# CHEROKEE METROPOLITAN DISTRICT

## LIFT STATION NO. 1 ADDITIONS

### SITE DEVELOPMENT PERMIT: PPR-2254

FILE NO.: PPR-2254

SHEET NO.  
**CL1.0**

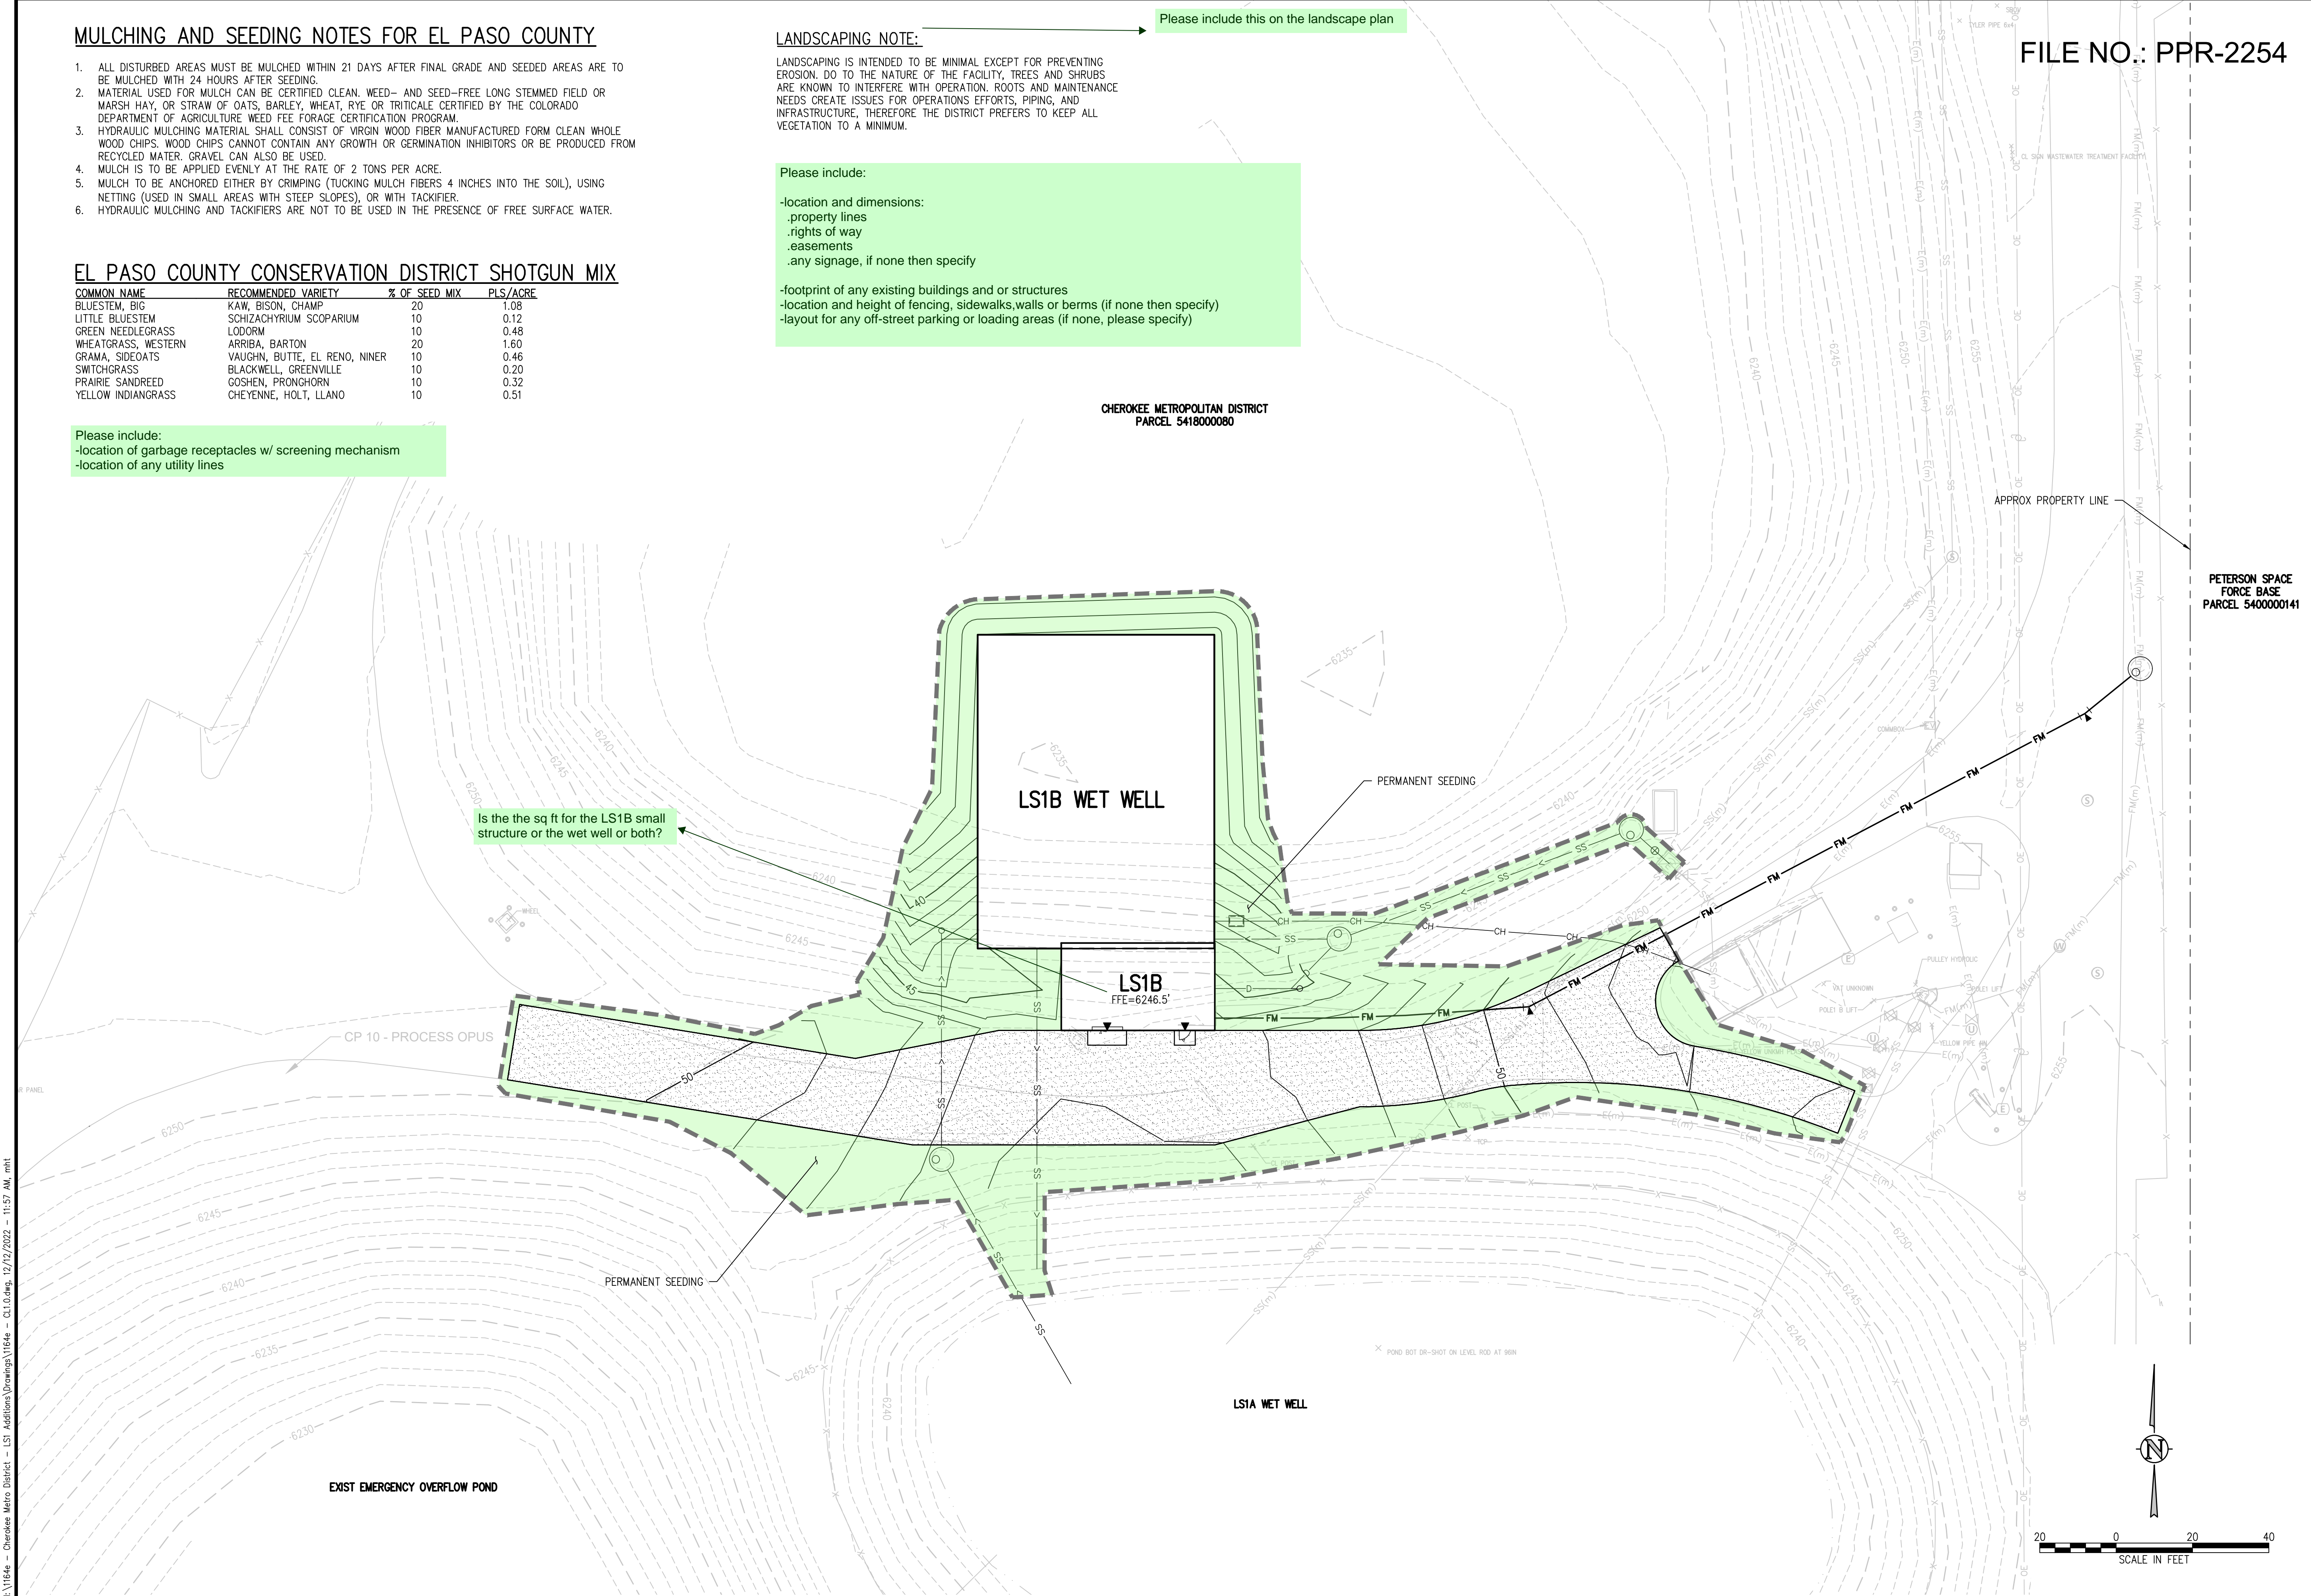
- Please include:
- location of garbage receptacles w/ screening mechanism
  - location of any utility lines

- Please include:
- location and dimensions:
    - .property lines
    - .rights of way
    - .easements
    - .any signage, if none then specify

- footprint of any existing buildings and or structures
- location and height of fencing, sidewalks, walls or berms (if none then specify)
- layout for any off-street parking or loading areas (if none, please specify)

Please include this on the landscape plan

Is the the sq ft for the LS1B small structure or the wet well or both?

SHEET NO.  
**C2.0**

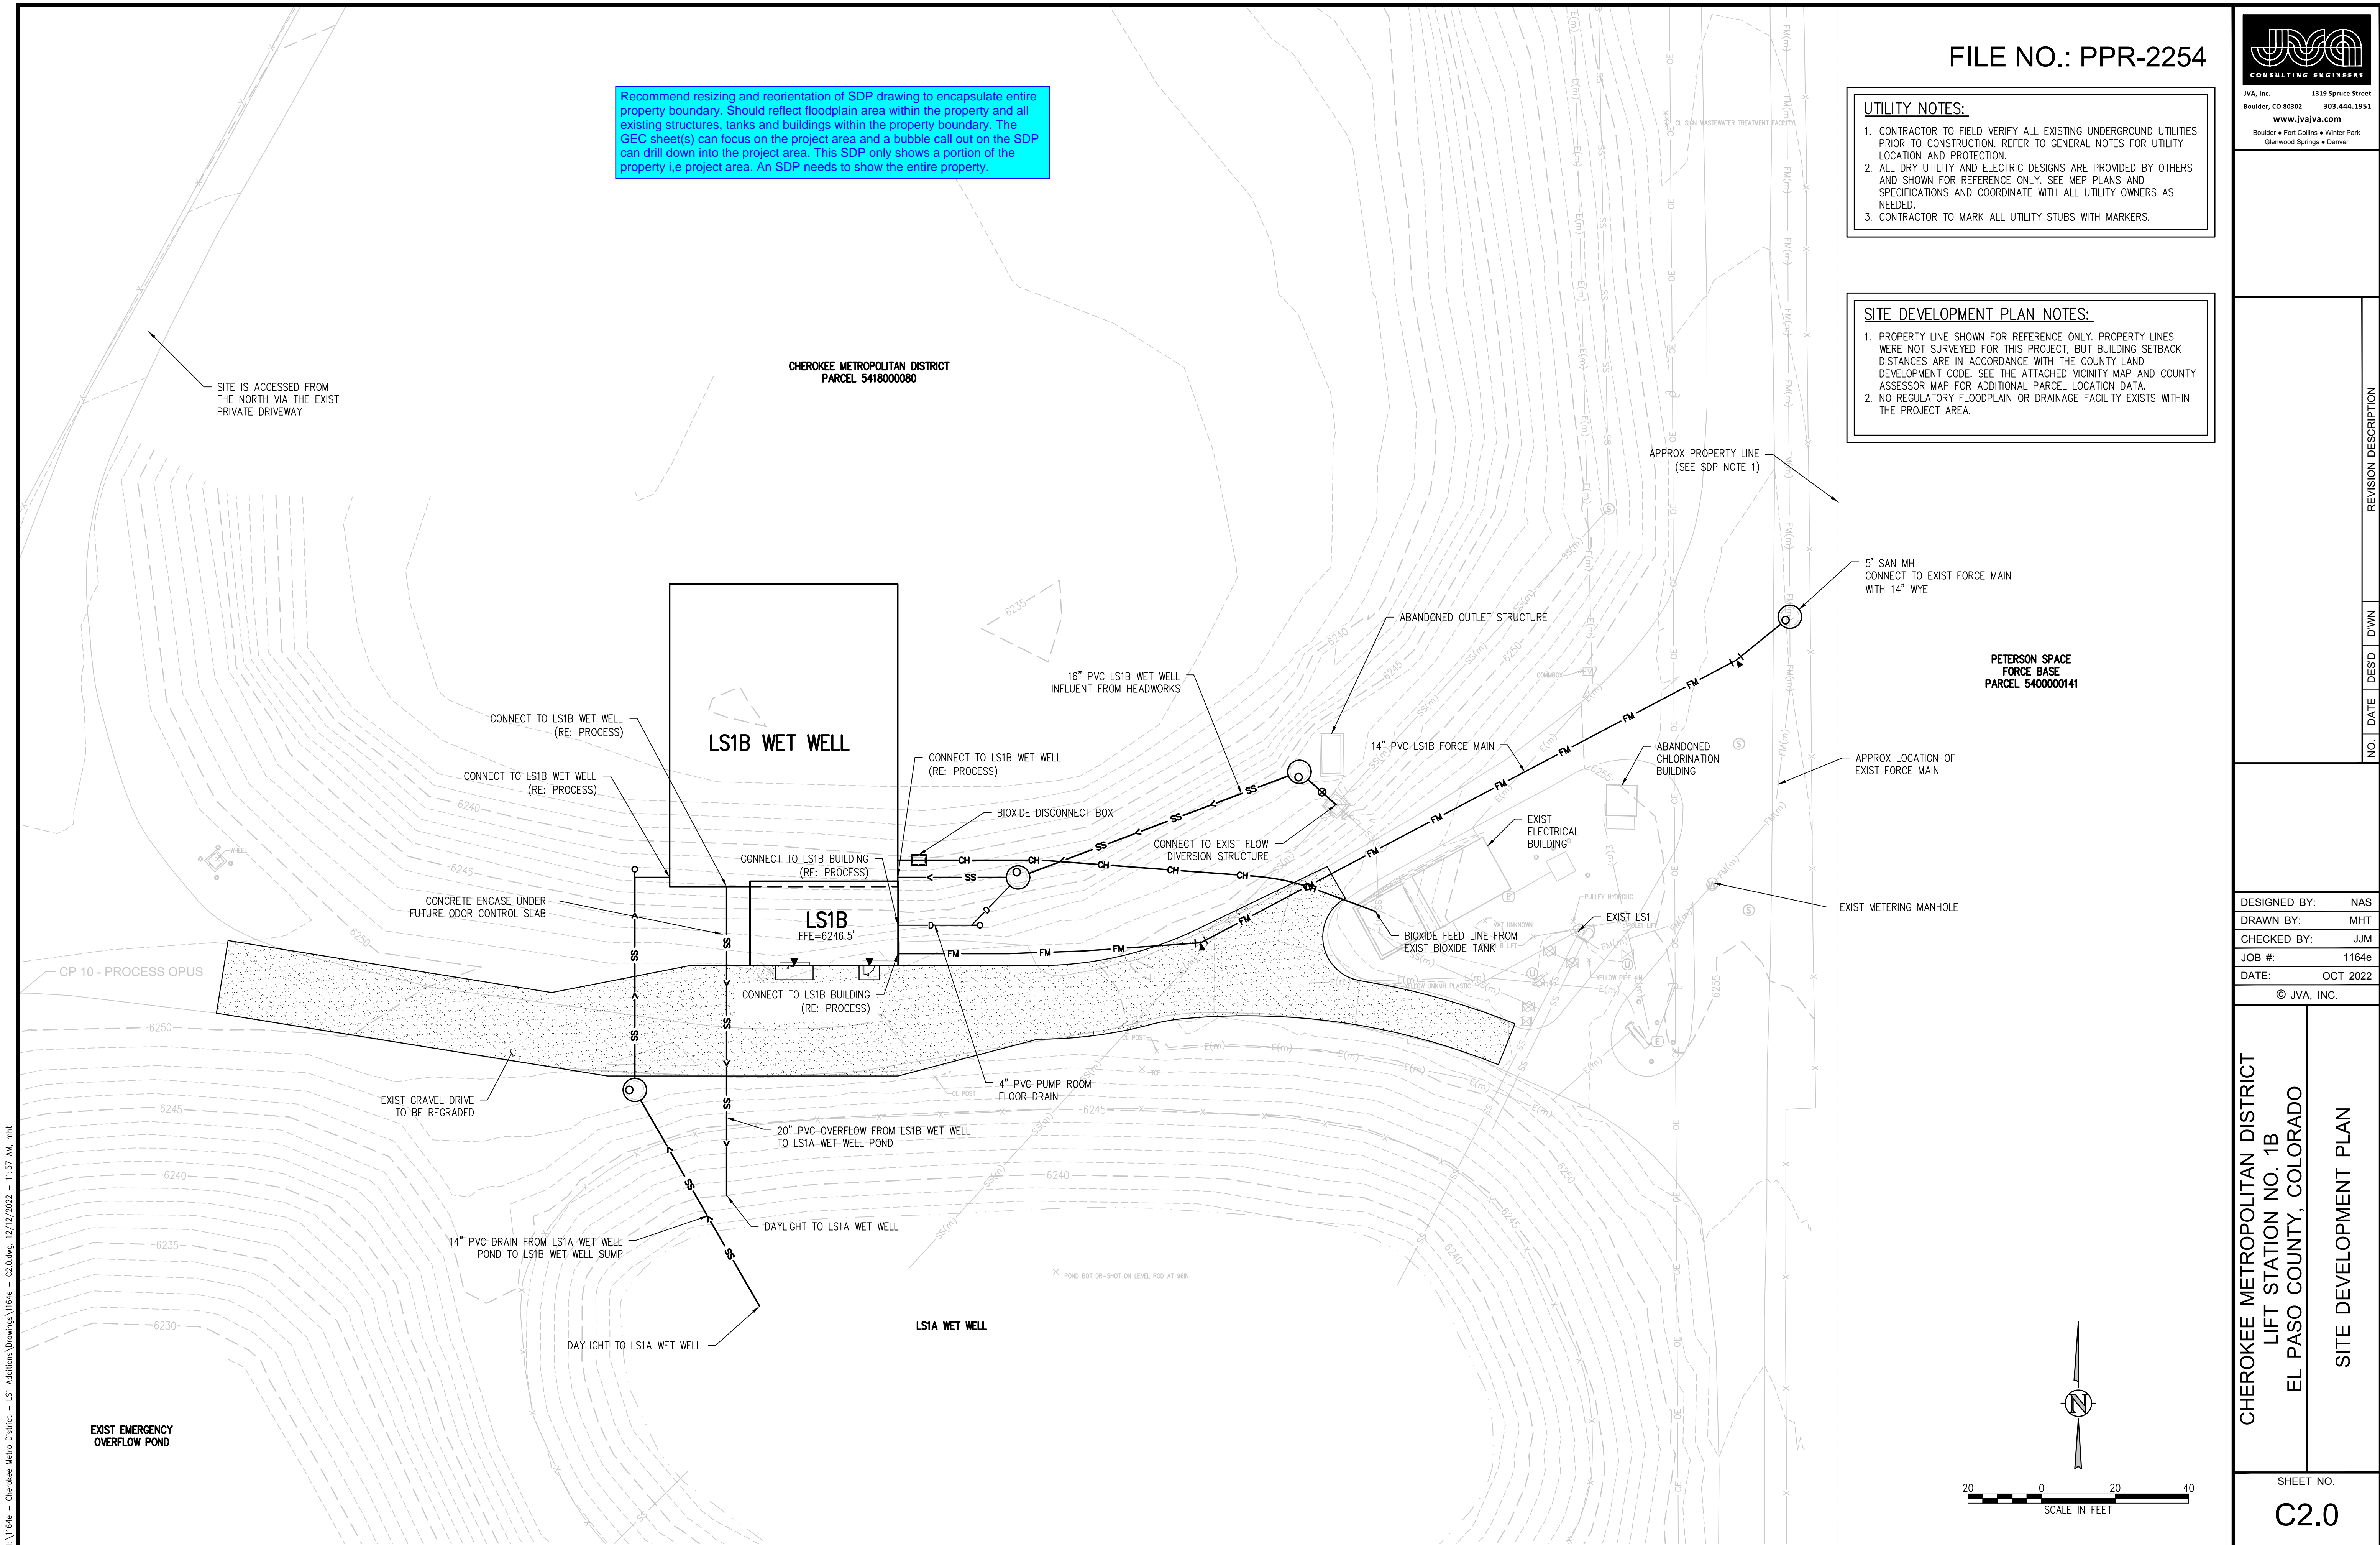
Recommend resizing and reorientation of SDP drawing to encapsulate entire property boundary. Should reflect floodplain area within the property and all existing structures, tanks and buildings within the property boundary. The CEC sheet(s) can focus on the project area and a bubble call out on the SDP can drill down into the project area. This SDP only shows a portion of the property i.e project area. An SDP needs to show the entire property.
